### Report Type: Sampling Plan nAB1817142364 / 2RP-4812

<b>Site:</b>	Rohmer #001				
<b>Company:</b>	Permian Water Solutions LLC				
<b>Section, Township and Range</b>	Unit F	Sec. 23	T 22S	R 27E	
<b>Lease Number:</b>					
<b>County:</b>	Eddy County				
<b>GPS:</b>	32.37889			-104.162648	
<b>Surface Owner:</b>					
<b>Mineral Owner:</b>					
<b>Directions:</b>	From intersection CR702 & CR216, travel north on 216 for 0.77 miles. Turn right onto Forni Rd. Follow Forni road for 0.41 miles, turn right onto lease road. Follow for 0.16 miles to location.

**RE: Sampling Plan  
Permian Water Solutions  
Rohmer #001  
Eddy County, New Mexico  
nAB1817142364  
2RP-4812**

FIGURE  
3

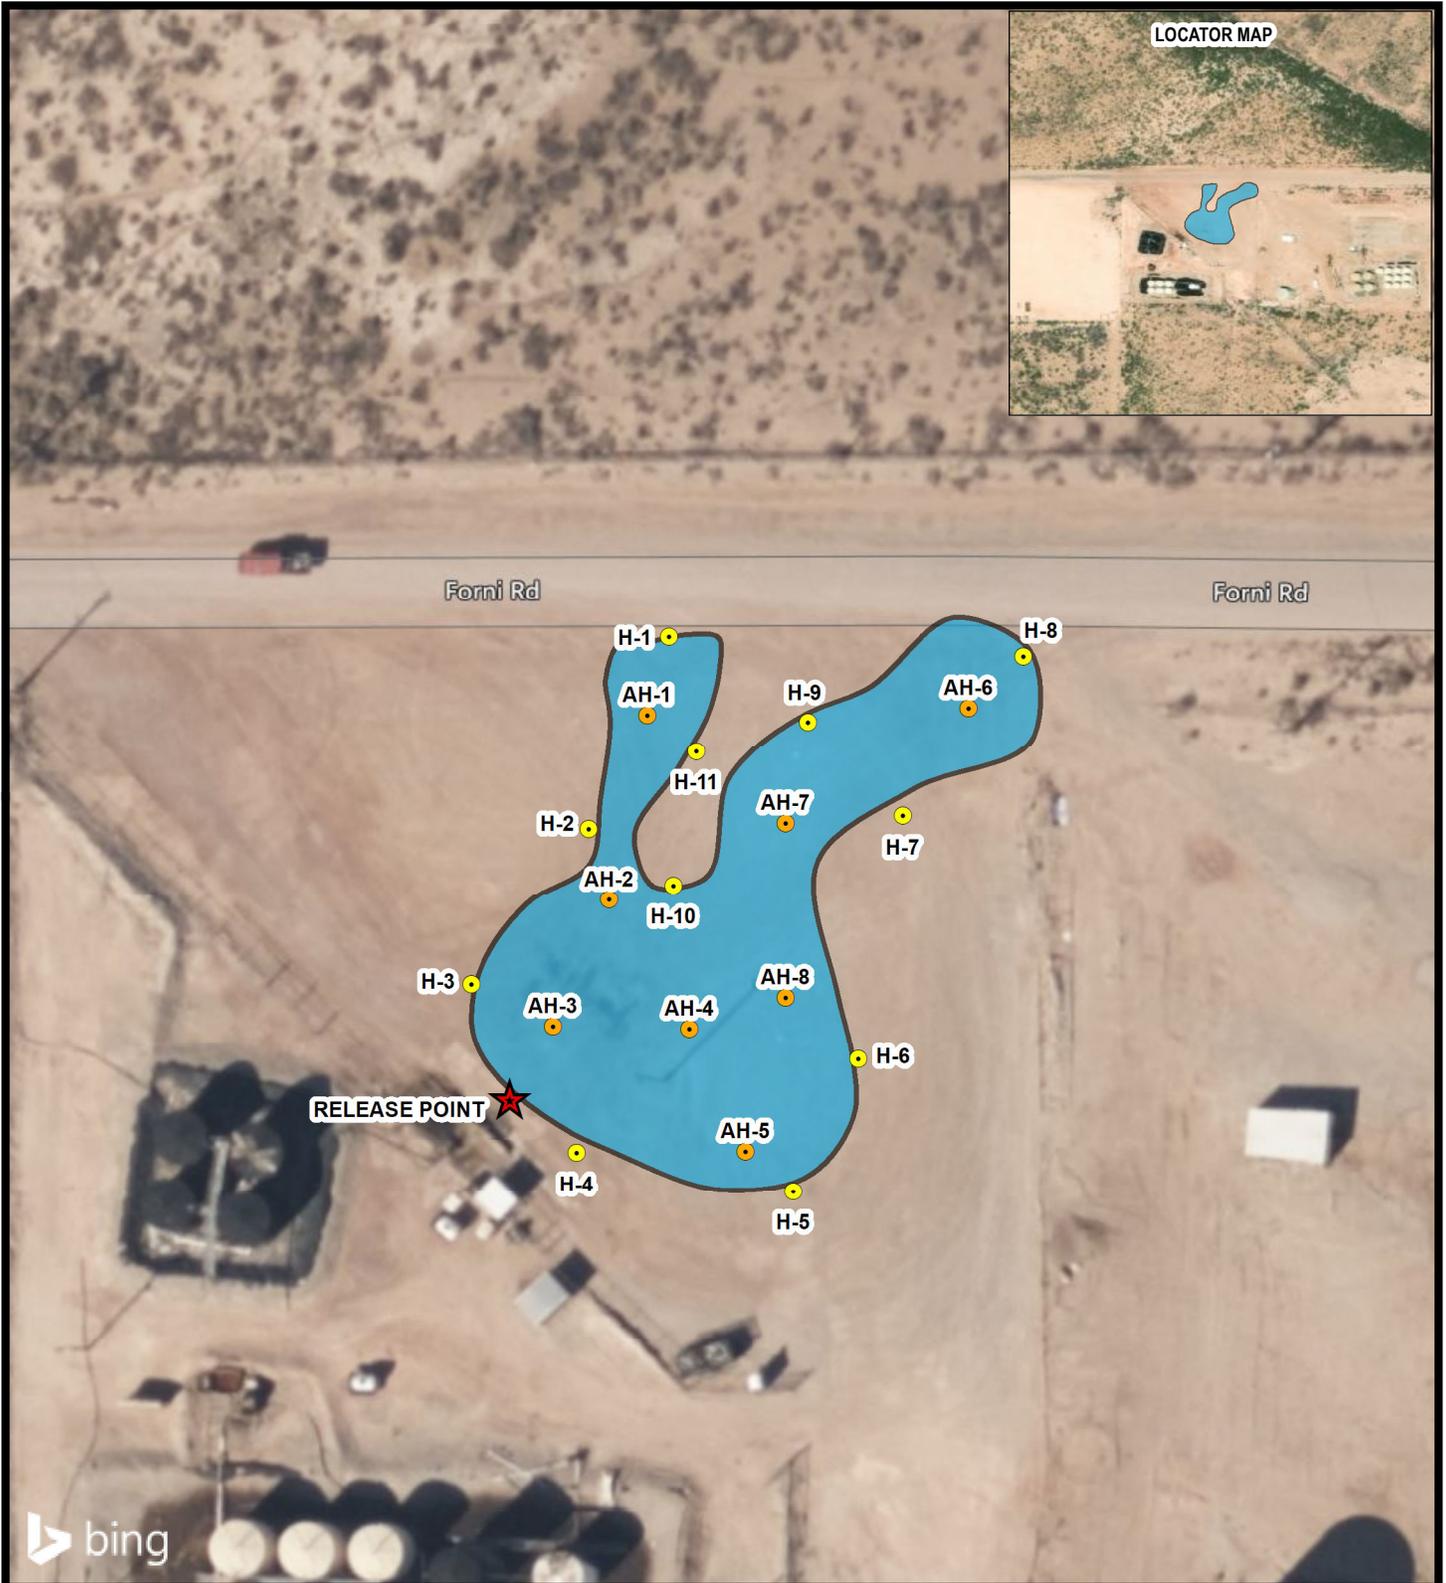
Created By	Condition	Condition Date
rhamlet	The Sampling Plan is conditionally approved. The release will need to be remediated to the strictest closure criteria standards. Sidewall samples should be delineated/excavated to 600 mg/kg for chlorides and 100 mg/kg for TPH to define the edge of the release. Samples must be analyzed for all constituents listed in Table I of 19.15.29.12 NMAC. Confirmation samples should be collected every 200 ft <sup>2</sup> . A remediation plan and/or closure report will need to be completed and uploaded within 90 days.	9/12/2022
